Docket No. 50-29

Subject: FEMA ANALYSIS OF THE PROMPT ALERT AND NOTIFICATION  
SYSTEM FOR THE YANKEE ROWE NUCLEAR POWER STATION

YANKEE NUCLEAR POWER STATION  
SITE-SPECIFIC OFFSITE RADIOLOGICAL EMERGENCY  
PREPAREDNESS ALERT AND NOTIFICATION SYSTEM  
QUALITY ASSURANCE VERIFICATION

FIGURE 6  
 COMPARATIVE OSPM RESULTS, VERY HILLY TERRAIN (FS 5TH TO SIREN)

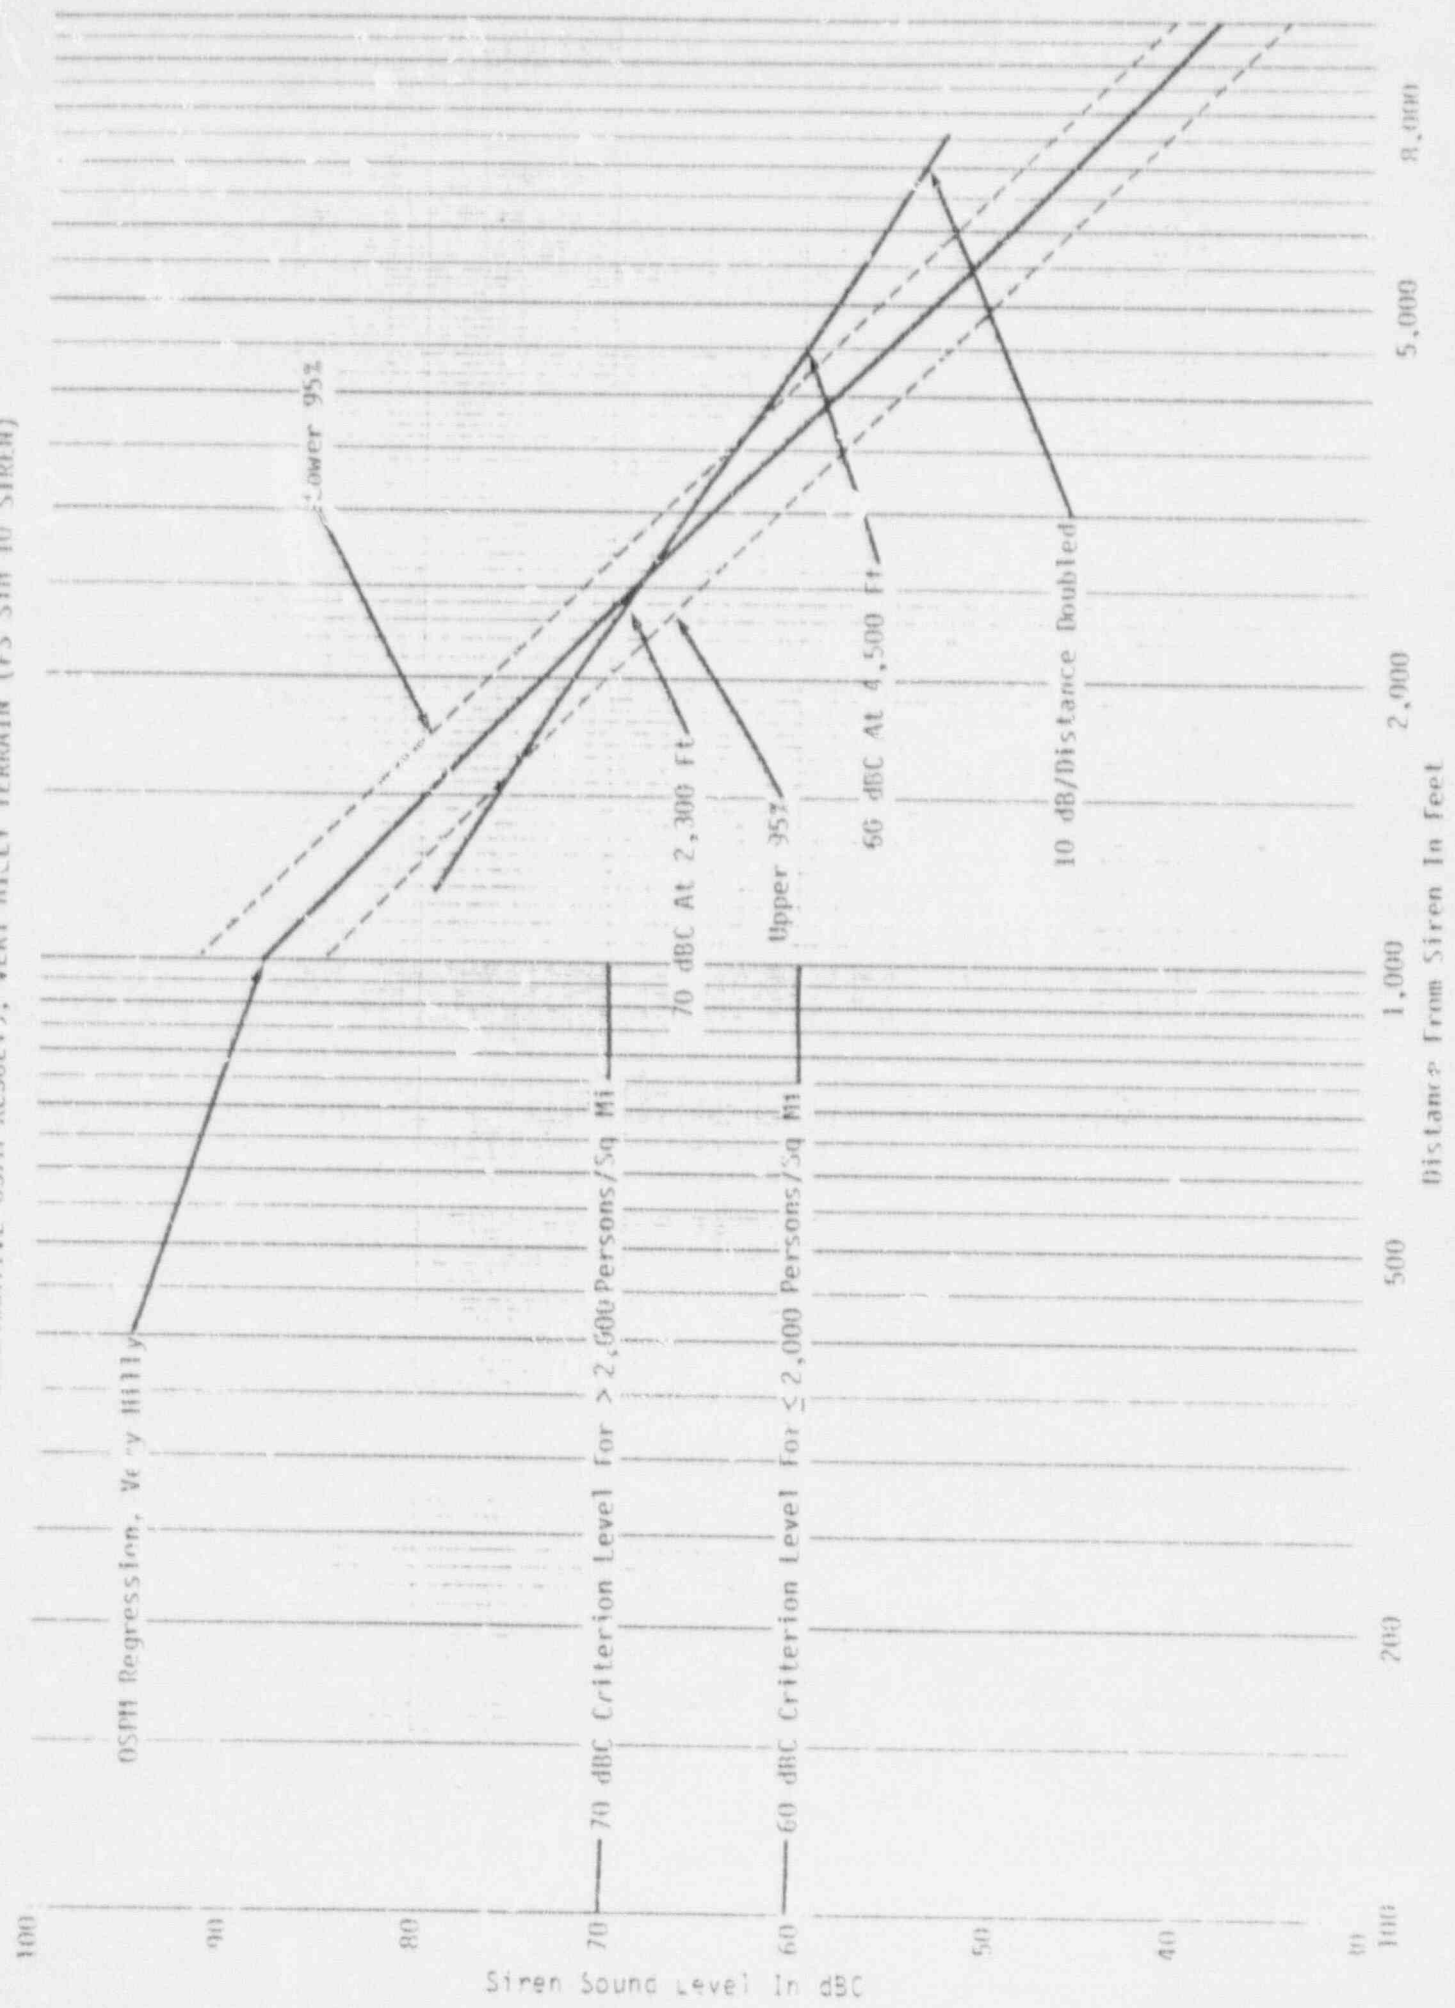
It was demonstrated by OSPM that essentially all of the populated areas within the EPZ of the USGS North Adams quadrangle map are expected to have a minimum siren sound pressure level of 60 dBC, and the area (City of North Adams) with more than 2,000 persons per square mile is expected to have a minimum siren sound pressure level of 70 dBC.

Comparisons of the OSPM-predicted 60 dBC and 70 dBC contours with the contours in the figures on pages 3-2-8 and 3-4-13 (Appendix 3) of the Design Report indicate that the coverage of the sirens as presented in the Design Report for North Adams is adequate.
